**ARBORIST REPORT/TREE PLAN**  
for  
**9252 Slater Avenue NE**  
**Kirkland, WA**

Attachment 6  
Dummer Buffer Mod  
SAR17-00155

**FIGURE 2**  
**MR. ISAAH DUMMER**  
**SLATER AVENUE PROPERTY**  
 KIRKLAND, WA  
 WETLAND BUFFER REDUCTION  
 EXISTING CONDITIONS

**FIGURE 3**  
**MR. ISAIAH DUMMER**  
**SLATER AVENUE PROPERTY**  
**KIRKLAND, WA**  
 WETLAND BUFFER REDUCTION  
**PROPOSED SITE PLAN & MITIGATION**

FIGURE 3  
 MR. ISAIAH DUMMER  
 SLATER AVENUE PROPERTY  
 KIRKLAND, WA  
 WETLAND BUFFER REDUCTION  
 PROPOSED SITE PLAN & MITIGATION

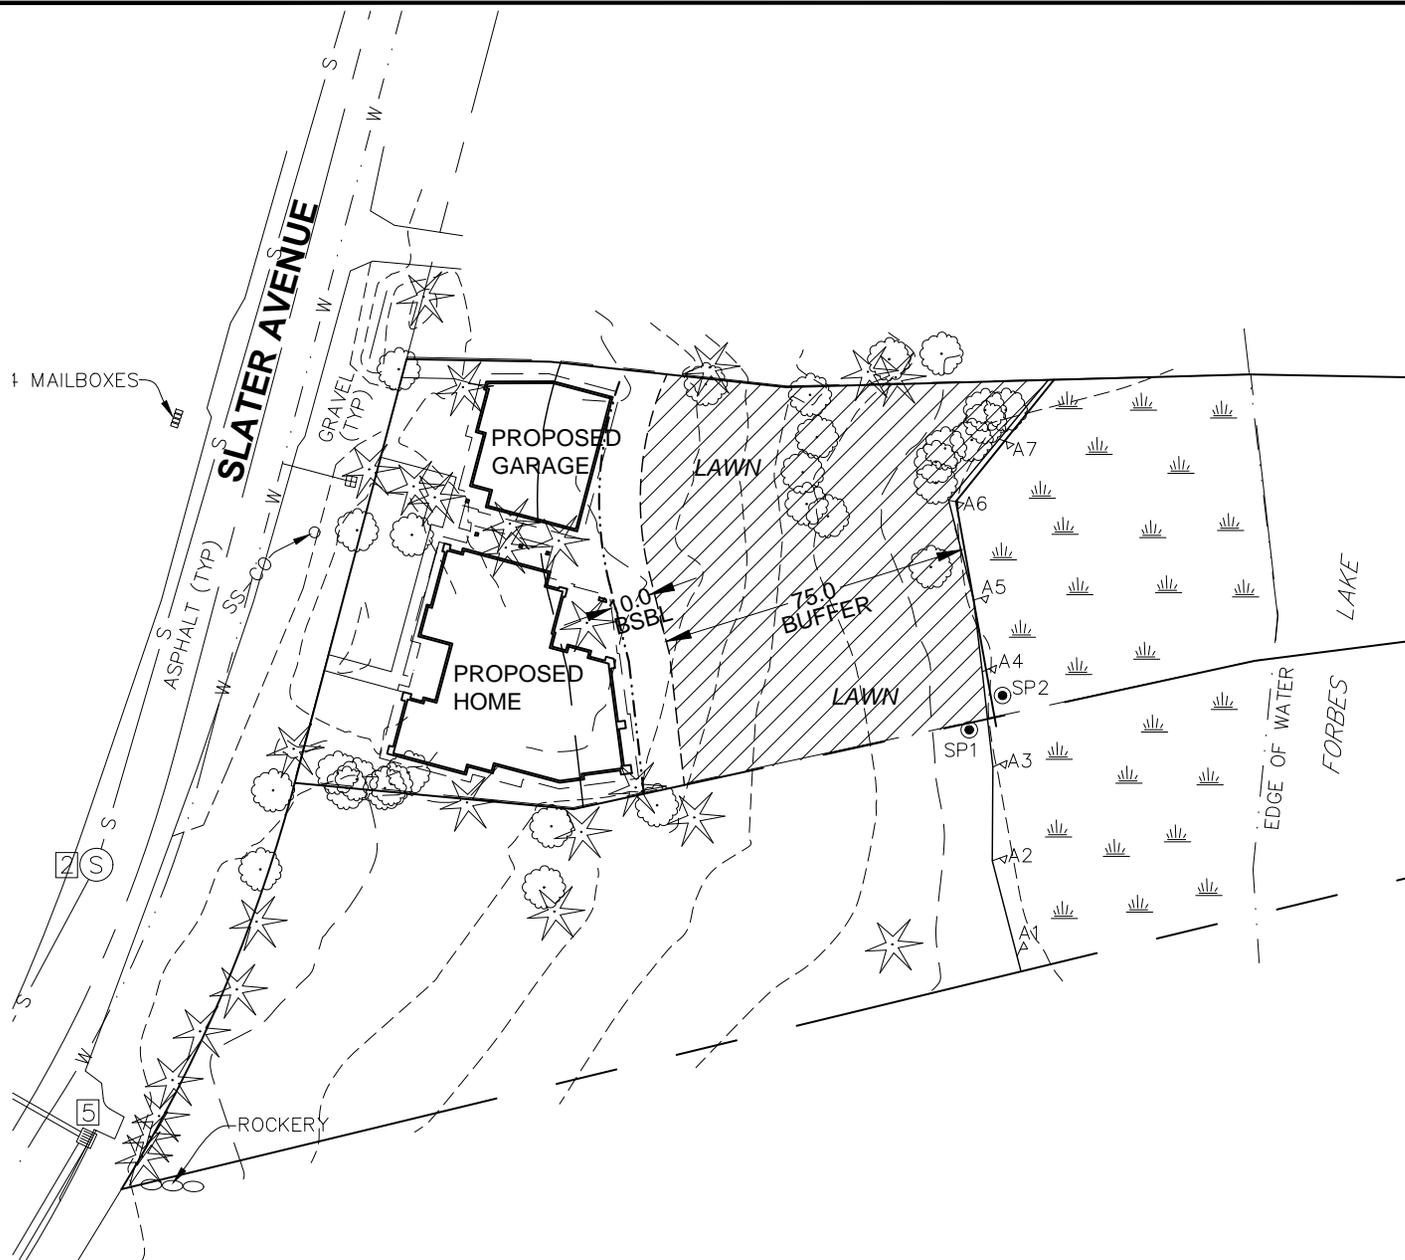
One more thing: According to 90.140 "Structure Setback from Critical Area Buffer", buildings and other structures shall be set back at least 10 feet from the edge of the wetland or stream to ensure adequate width for construction staging, maintenance and repair of primary buildings and accessory structures..." The proposed detached garage with second story living quarters is exactly 75 ft from the lake edge. Even with the wetlands buffer modified from 100 ft to 75 ft, as requested in application SAR17-00155, the structure would not have the necessary 10 ft. set back from the wetlands buffer.

2) Chapter 90 code says that Wetland Buffers can be reduced by up to one-fourth (25%) (going from 100 ft to 75 ft) if the applicant covers the buffer with native vegetation. Native cover would mean that at least 80 percent of the buffer area has a mix of multi-age forest canopy, shrubs and woody ground cover with native plants and no lawn. Nowhere in the public application does it indicate that Mr. Dummer is committing to covering the wetland buffer with native vegetation. Instead, the plans show that Mr. Dummer will be removing 7 mature trees and the existing 1,060 sq ft house to build a 4,600+ sq ft house that comes within inches of the north and south property lines and has the minimum required road set back. In addition, the schematics show a retaining wall between the proposed house and the lake, suggesting a graded outdoor area connected with the house (a lawn perhaps).

The removal of 7 mature trees, the full use of the every inch of buildable space to create a 4.5x larger house, and the addition of retaining walls suggest that Mr. Dummer is not planning to create and maintain native vegetation if he gets the Wetlands Buffer mitigation. If he is proposing a native vegetation mitigation, his proposal should be viewed with deep skepticism.
